# MAYBERRY COMMUNITIES MASTER DEVELOPMENT DRAINAGE PLAN

## MAYBERRY, COLORADO SPRINGS

ORIGINAL SUBMITTAL: JULY 2023

# V1\_Master Development Drainage Plan (MDDP).pdf Markup Summary

HISTORIC DRAINAGE PLAN

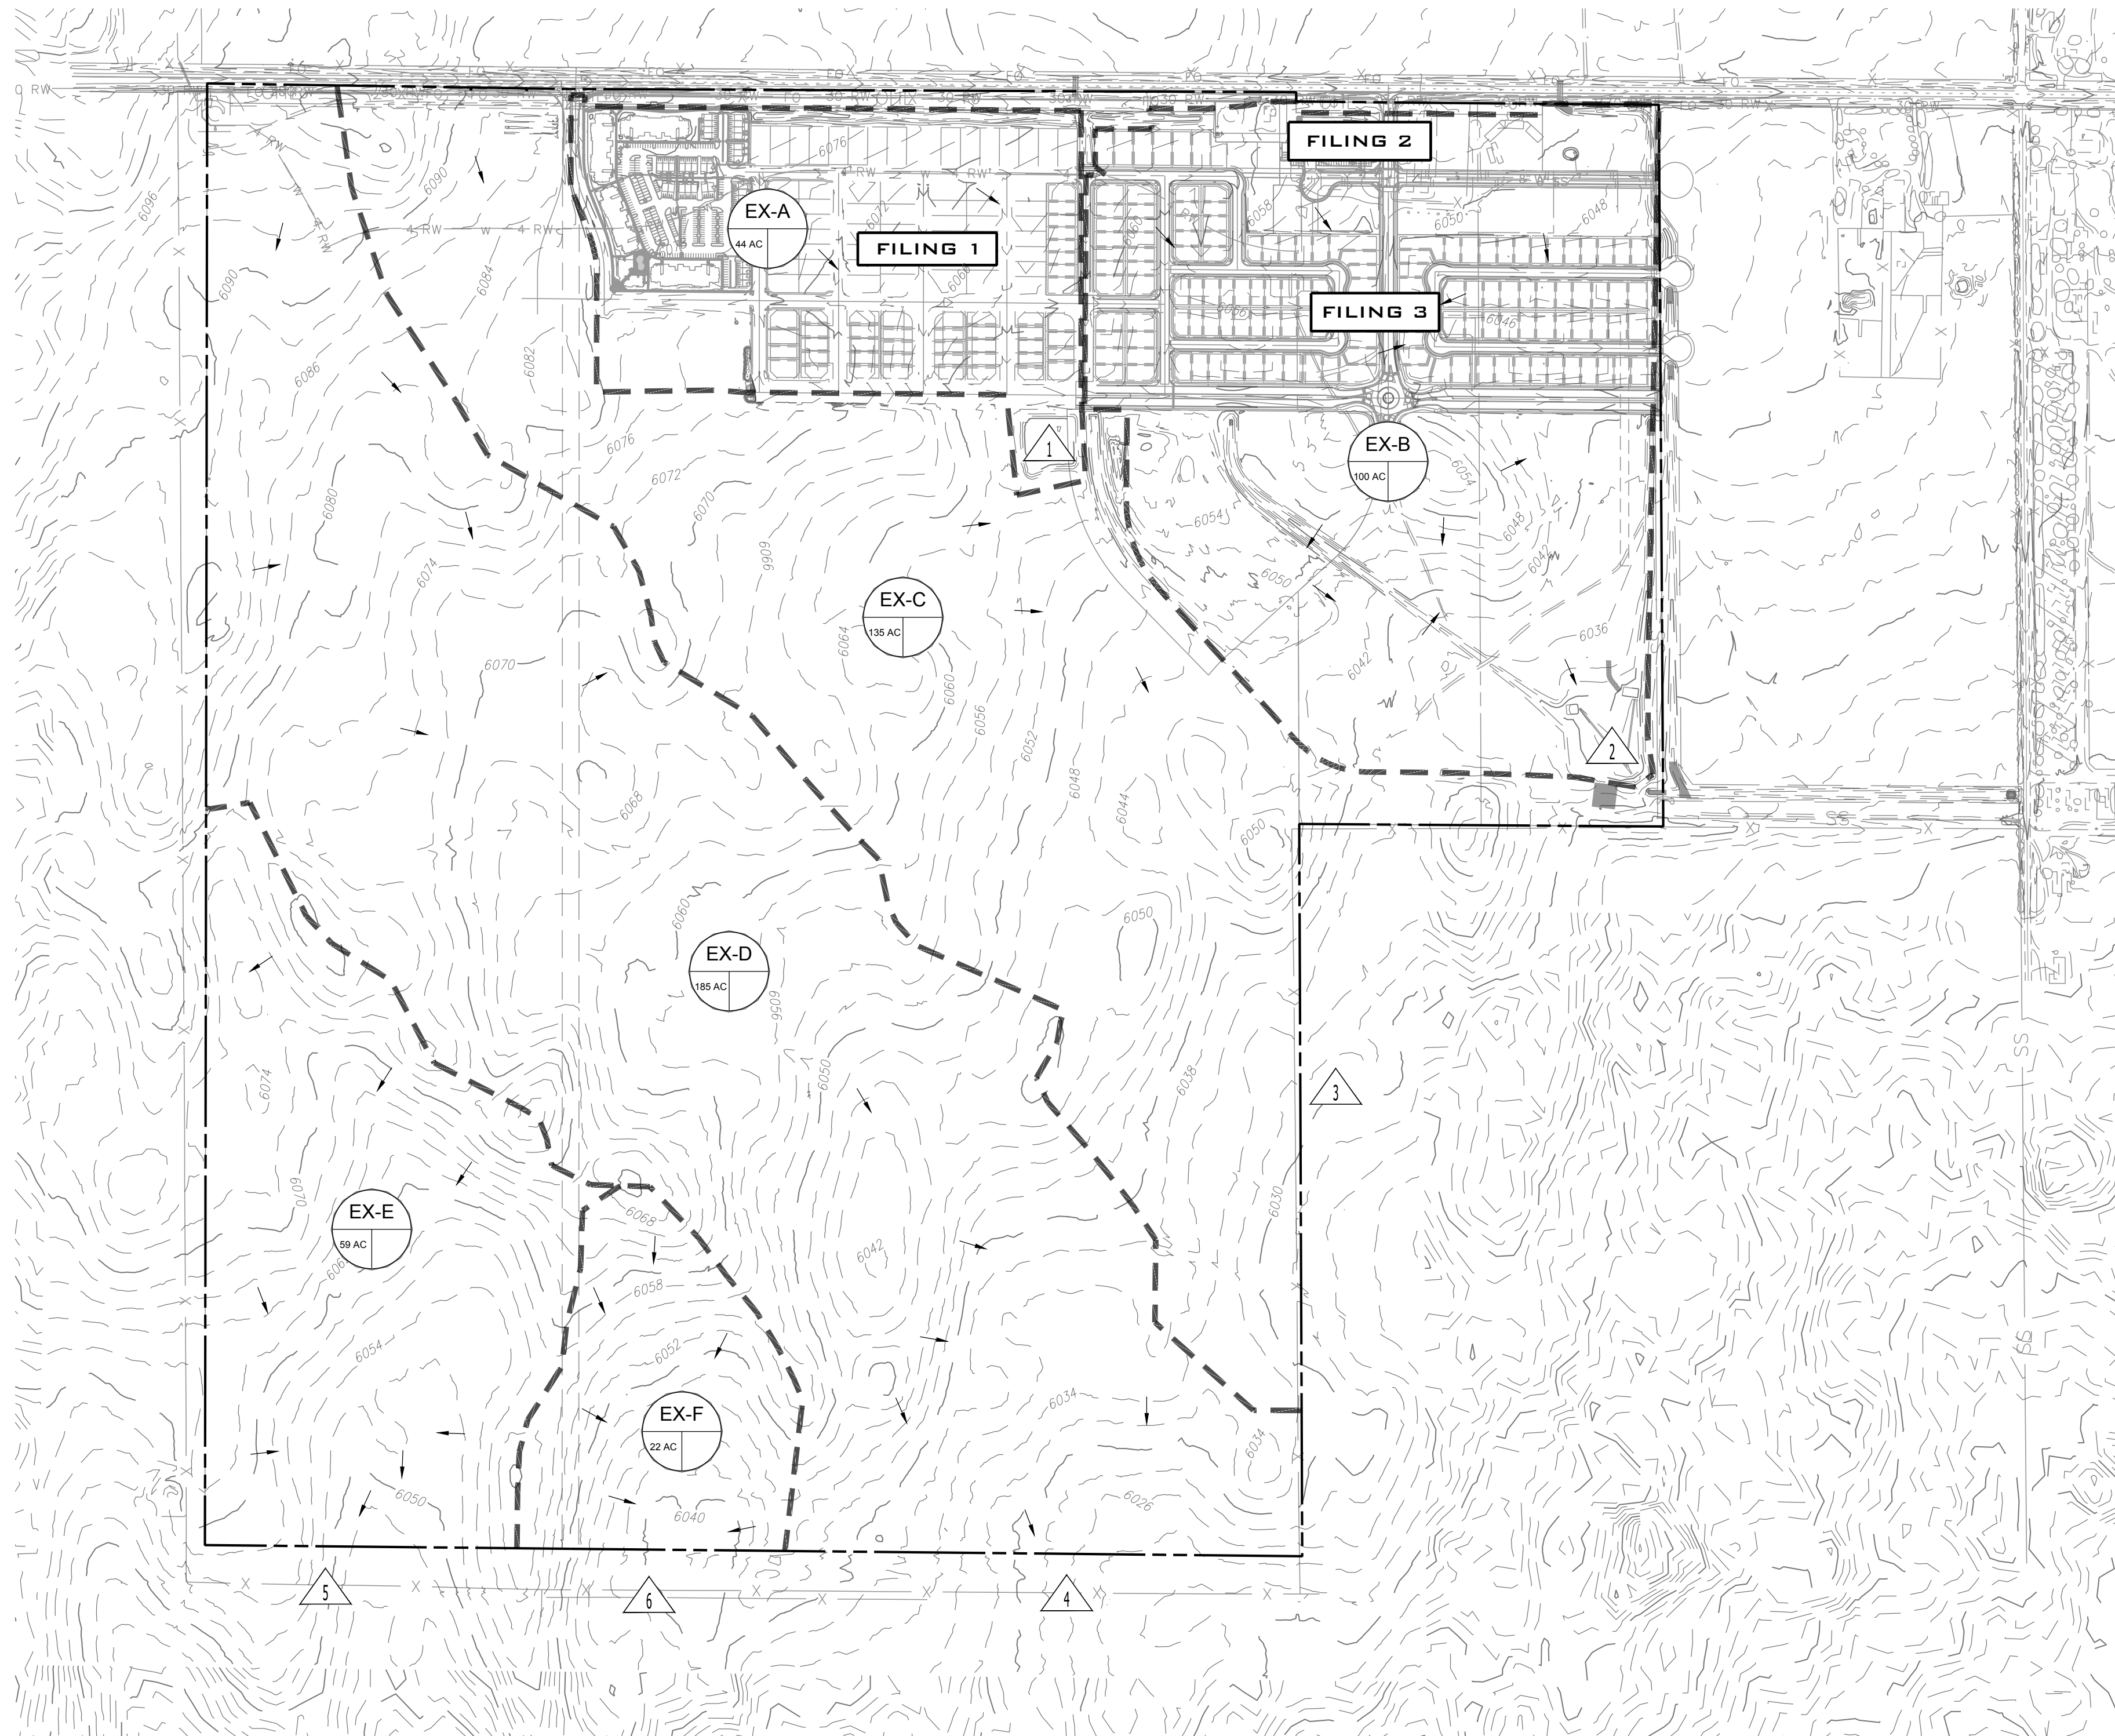
please also show offsite basins with flow arrows on the existing drainage maps

provide a design point summary table with 5 and 100yr flows

label the locations of the existing CMP on the northern boundary conveying off-site flow onto the site and provide design points with runoff values.

The road names have changed in the Sketch plan.

**OVERALL PROPOSED DRAINAGE MAP**

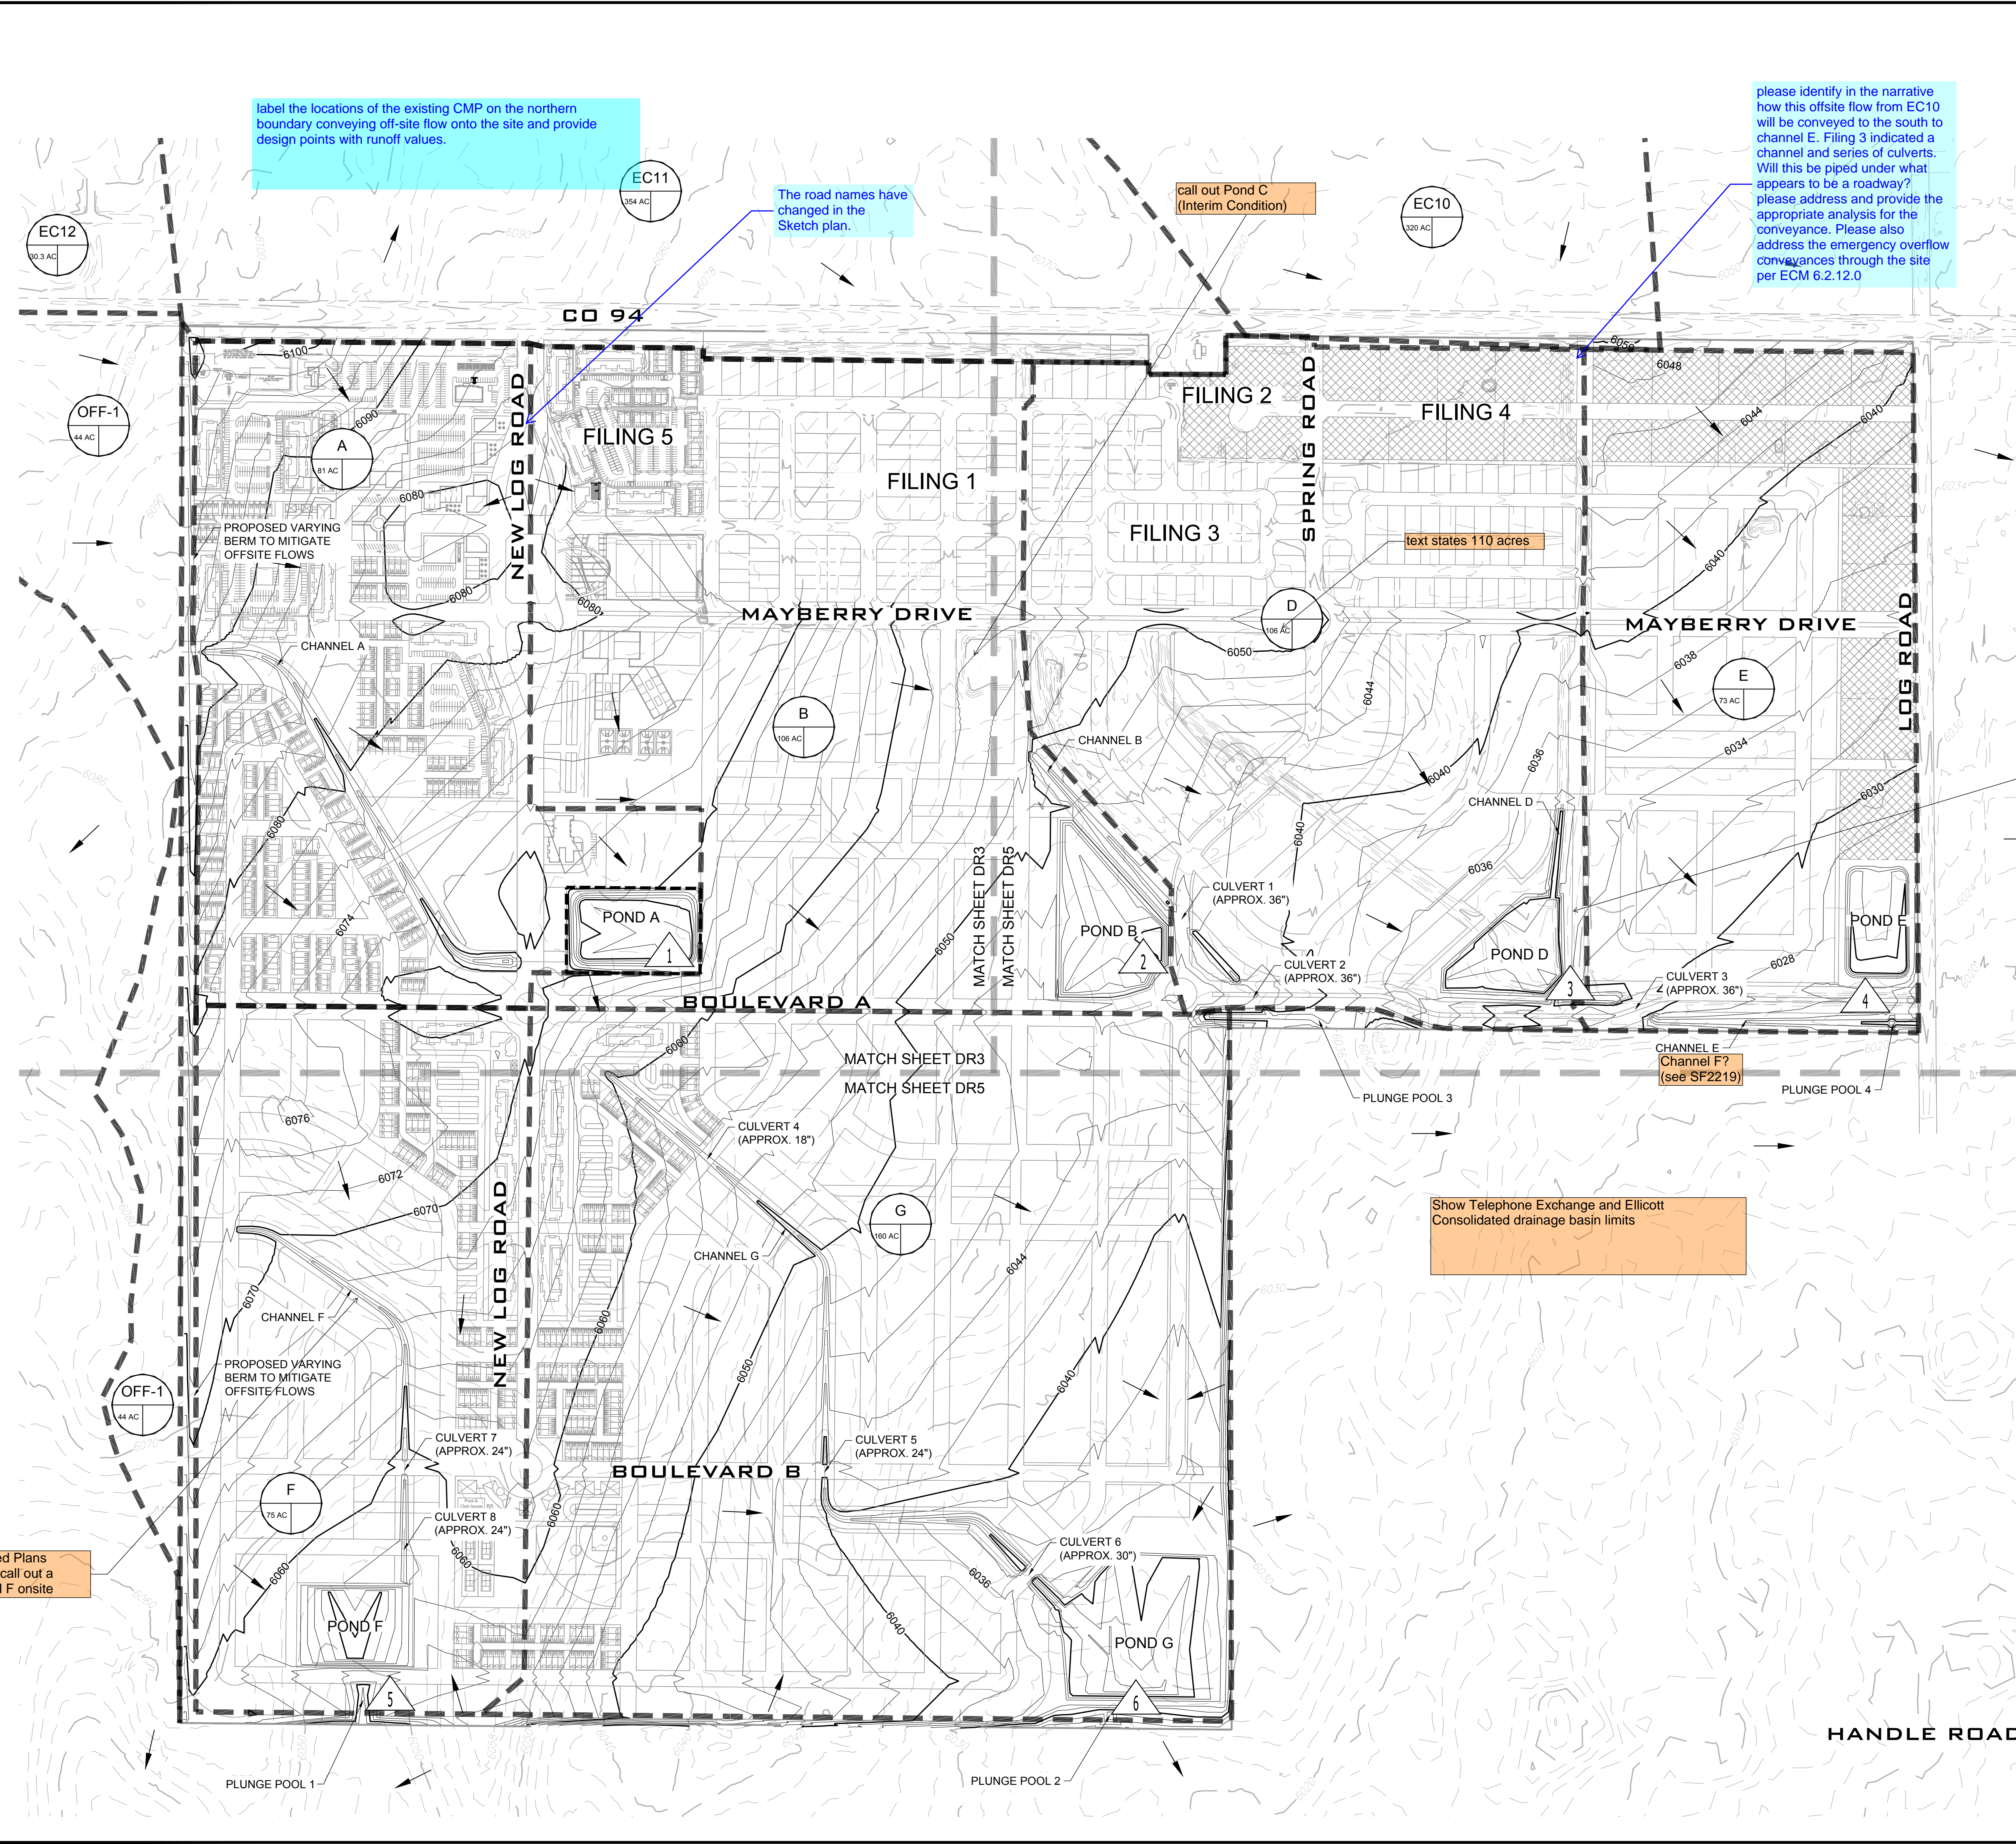
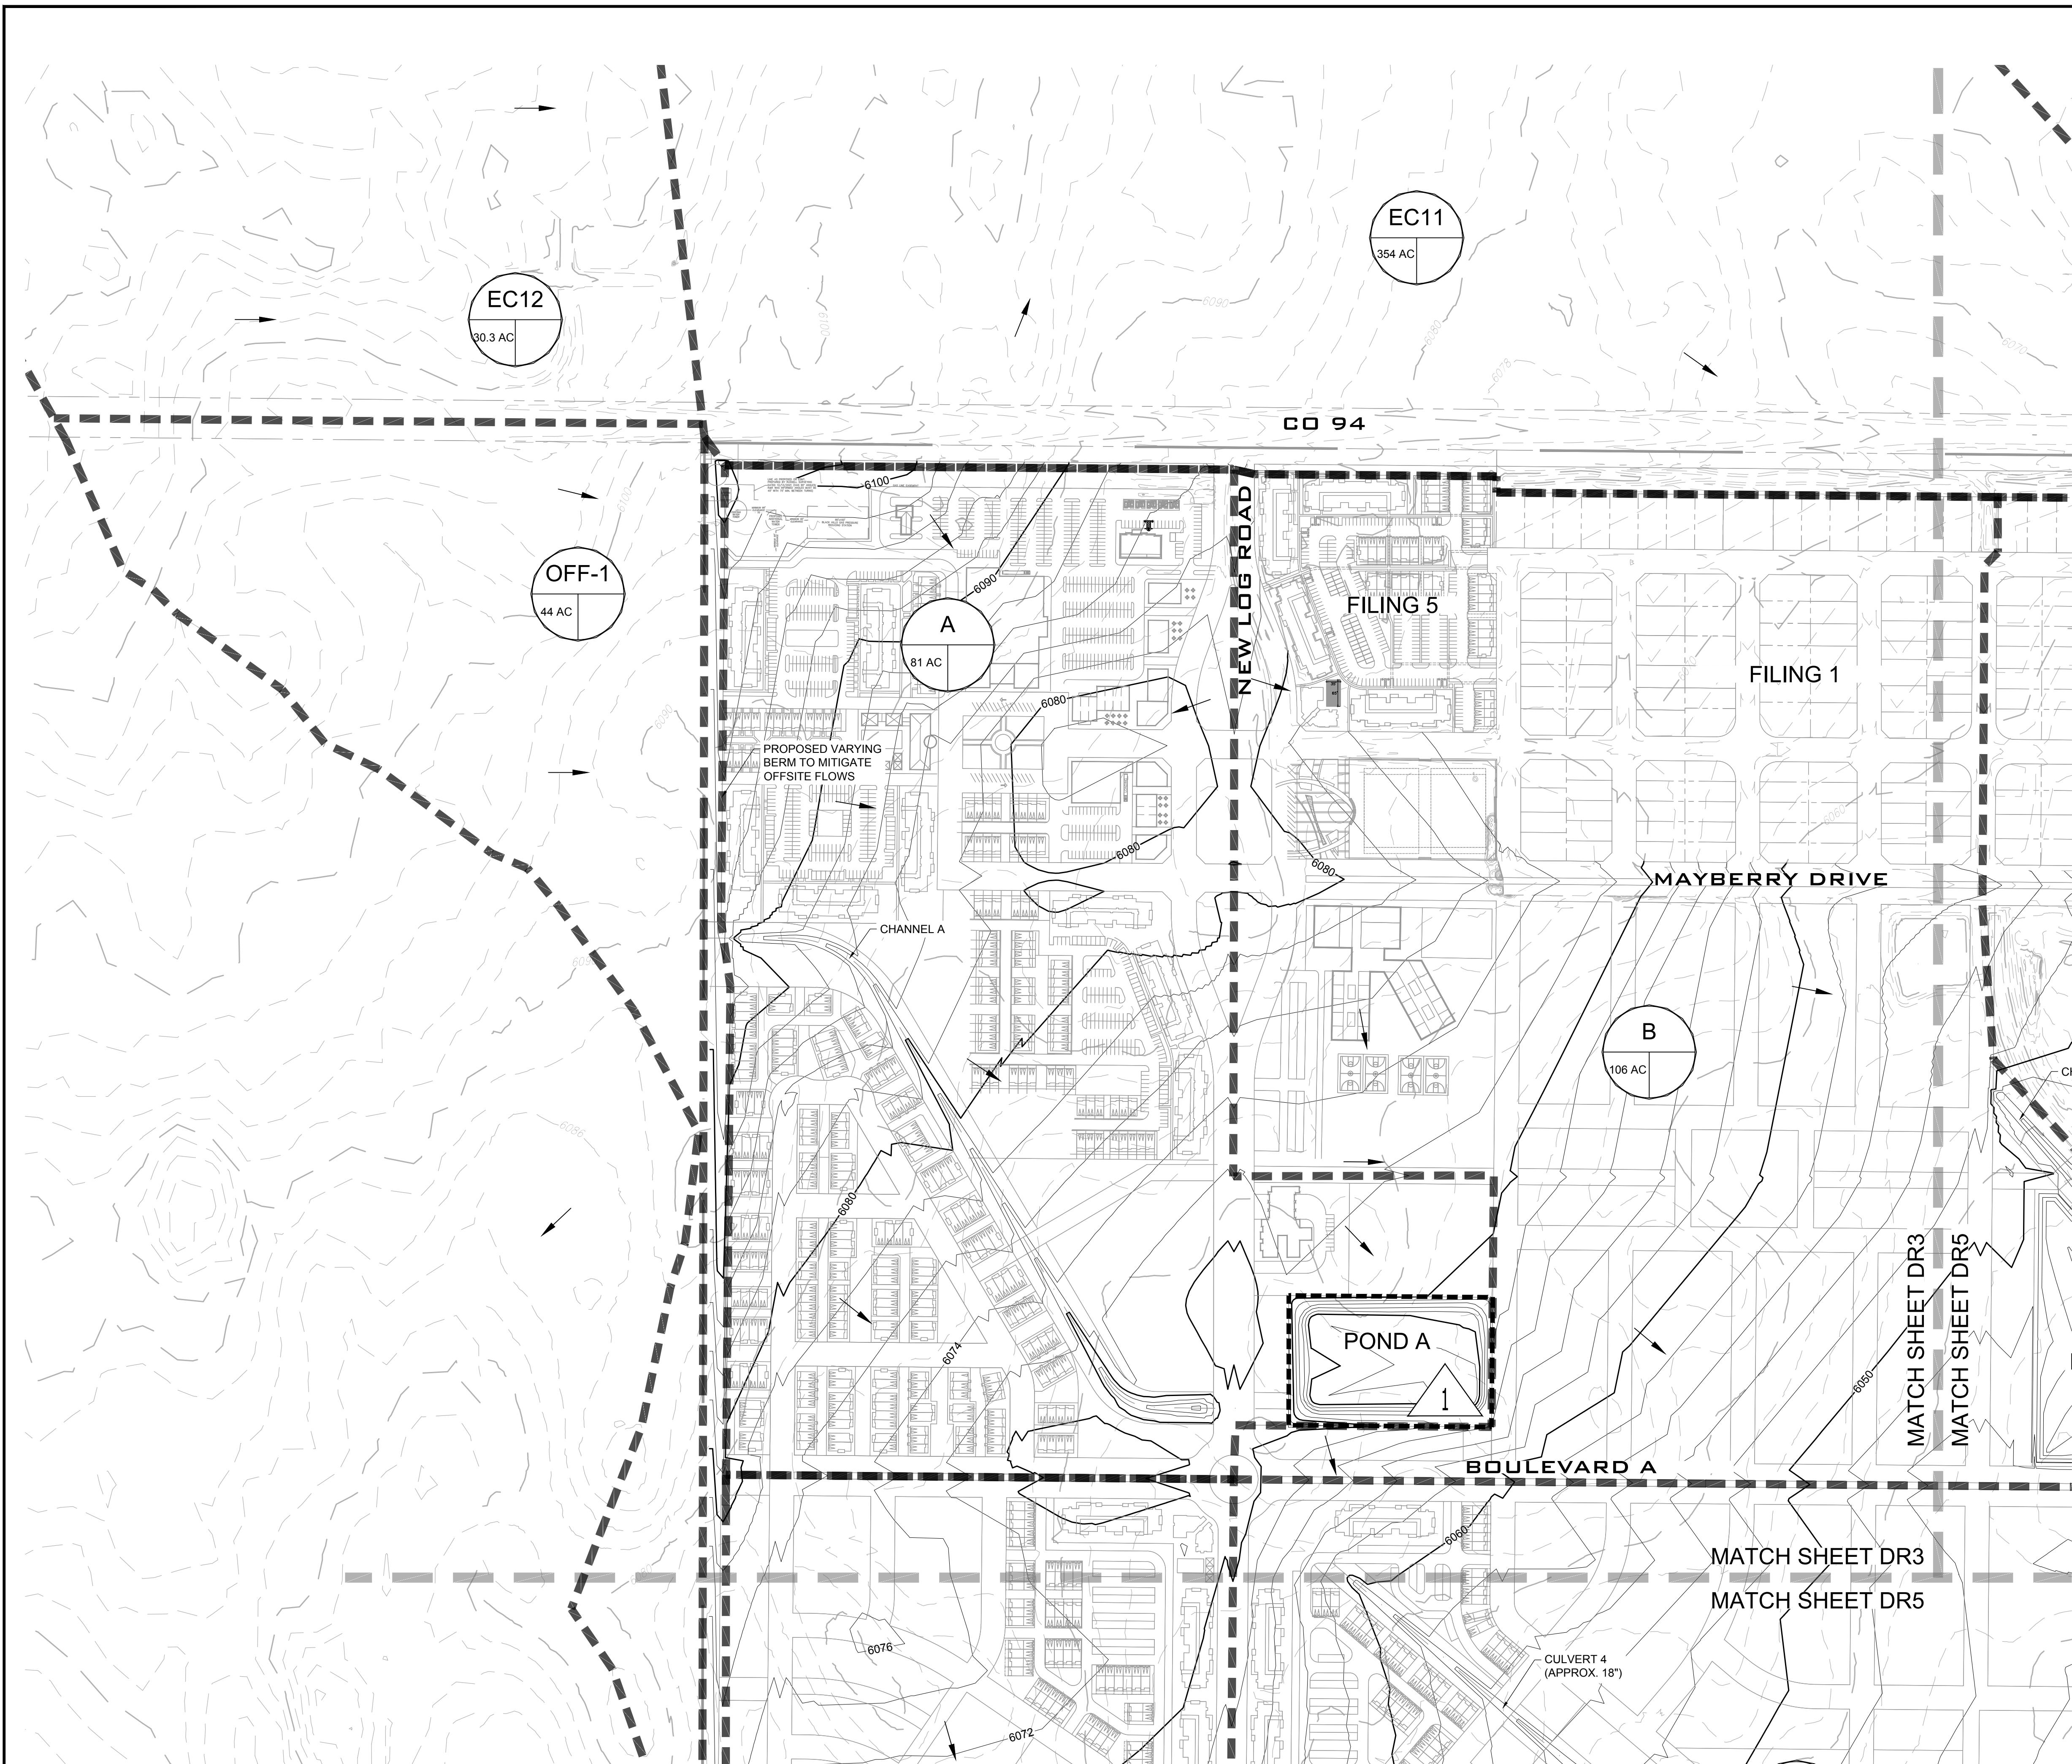
please identify in the narrative how this offsite flow from EC10 will be conveyed to the south to channel E. Filing 3 indicated a channel and series of culverts. Will this be piped under what appears to be a roadway? please address and provide the appropriate analysis for the conveyance. Please also address the emergency overflow conveyances through the site per ECM 6.2.12.0

provide a design point summary table with 5 and 100yr flows

Show Telephone Exchange and Ellicott Consolidated drainage basin limits

Approved Plans already call out a Channel F onsite
